HISTORIC AND DESIGN REVIEW COMMISSION

HDRC CASE NO: 2019-278

ADDRESS: 2265 AUSTIN HWY

TYPE OF WORK: Construction of a 1-story fire station

1 Site Plan SCALE: 1" = 20'-0"

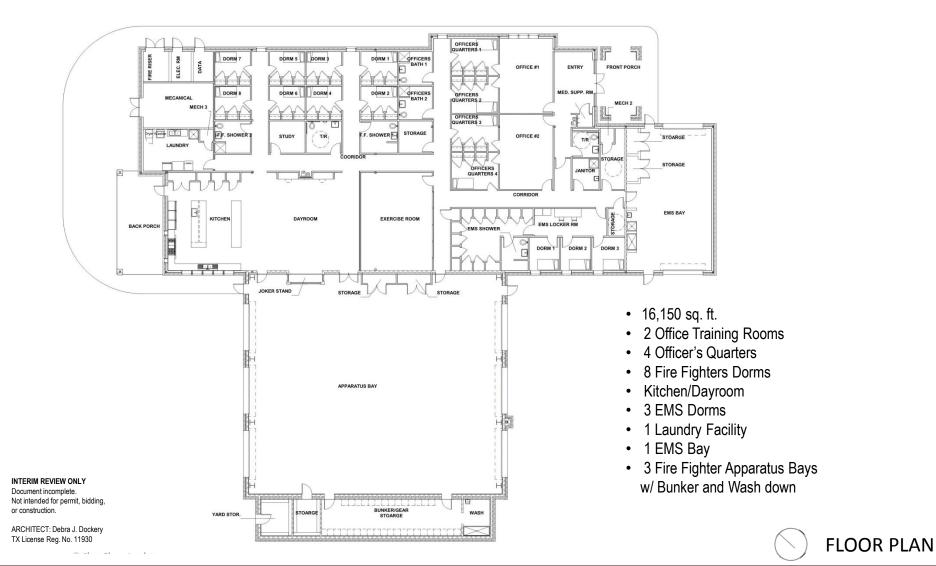
- d. MECHANICAL EQUIPMENT The applicant is responsible for screening all mechanical equipment in conformance with UDC Section 35-642(b)(6).
- e. HARDSCAPING AND PARKING The applicant has proposed to install 28'-0" and 36'-0" wide driveways, which will provide access to the new facility. The larger driveway will access the fire truck bay and the smaller driveway will provide access to a rear parking lot for employees and visitors, as well as a trash receptacle area. Staff finds the proposal generally consistent with the UDC. Staff is responsible for complying with UDC standards for screening and landscaping as noted in finding f, and for verifying parking and egress requirements with the appropriate Development Services Department divisions and reviewers.

- f. LANDSCAPING According to the UDC, parking areas should be screened from view from the public right-of-way and should feature attractive fences, berms, plantings, or other means appropriate to the site. Per the submitted site plan, landscaping elements will be incorporated on the northern, western, and eastern edges of the proposed structure to screen parking and the building. Staff finds this to be generally consistent with the UDC, but Staff requires a final landscaping plan indicating the location and species of all proposed plantings.

- i. That the applicant submits all material specification information and a full landscaping and hardscaping plan for final approval.
- ii. That the applicant submits comprehensive information on proposed signage for final approval, if applicable.
- iii. ARCHAEOLOGY The project shall comply with all federal, state, and local laws, rules, and regulations
